# Access Compliance Report

## Public Rights-of-Way

### (Curb Ramps)

Intersection ID: 14253	Main Street: LUTHER_ST	Cross Street: S_TORRENCE_ST	Location: SE
ADA ID: 0F743D13CCC2	Ramp Type: PerpDiag	Initial Pass/Fail: Fail	Overall Compliance: No
			Severity Score: 33.75

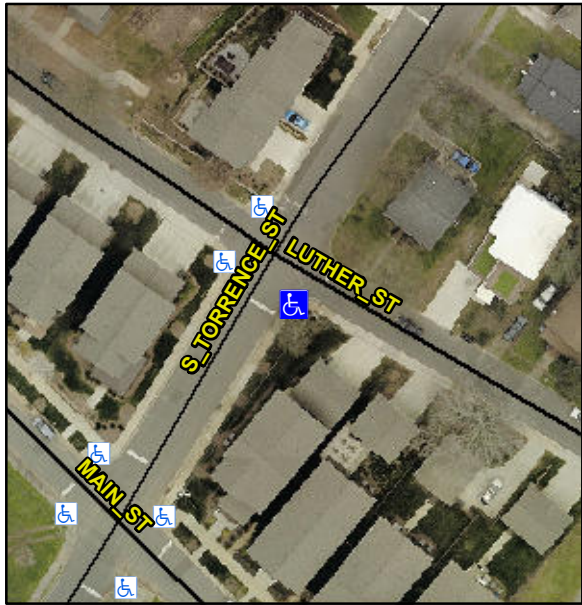
Codes/Mitigation Info/Possible Solution			Field Measurements/Component Compliance					
	Possible Solutions:		Compliance	Description	Data	Compliance	Description	Data
	Remove & Replace Curb Ramp With Two New Directional Ramps or Equivalent.		N/A	Ramp Length (in)	55.0	Yes	Ramp Slope (%)	6.9
			No	Ramp Width (in)	36.0	No	Ramp XSlope (%)	7.2
			N/A	Flare Type LT	N/A	N/A	Flare Type RT	N/A
			N/A	Flare Slope LT (%)	N/A	N/A	Flare Slope RT (%)	N/A
			N/A	Flare Traversable LT?	N/A	N/A	Flare Traversable RT?	N/A
			N/A	Landing Length (in)	N/A	N/A	DWS Provided?	N/A
			N/A	Landing Width (in)	N/A	N/A	DWS Contrast?	N/A
			N/A	Landing Slope (%)	N/A	N/A	DWS Length (in)	N/A
			N/A	Landing X Slope (%)	N/A	N/A	DWS Full Width?	N/A
Surveyor Notes:	N/A		N/A	Landing Curb? (Y/N)	N/A	N/A	DWS Offset (in)	N/A
			N/A	Shared Landing?	N/A			
	PROW/ADA:		N/A	Gutter Ponding?	N/A	N/A	Gutter Slope (%)	N/A
	Not Found, R304.5.1, R304.5.3		N/A	Gutter Lip Ht (in)	N/A	N/A	Gutter X Slope (%)	N/A

N/A	Painted X Walk1?	No	N/A	Painted X Walk2?	No
				X Walk 1 Direction	To NE		X Walk 2 Direction	To NW
			N/A	X Walk 1 Width (in)	N/A	N/A	X Walk 2 Width (in)	N/A
				X Walk 1 Slope (%)	7.8		X Walk 2 Slope (%)	1.8
				X Walk 1 X Slope (%)	2.6		X Walk 2 X Slope (%)	8.5
			N/A	Ramp inside XWalk1?	N/A	N/A	Ramp inside XWalk2?	N/A
Street 1 Name LUTHER ST Stop Condition-Street 2 StopSign Street 2 Name S TORRENCE ST Stop Condition-Street 1 StopSign				Road Slope (%)	6.1	N/A	Clear Space?	N/A
				Road X Slope (%)	4.1	N/A	Clear Space to XWalk (in)	N/A
			N/A	Any Obstructions?	N/A	N/A	Storm Grate/Utility Hazard?	N/A
				Obstruction Type			Storm Grate/Utility Type	
					N/A			N/A
						Yes	Surface Condition? (G/P)	Good
	Total Cost:		\$	3200.00
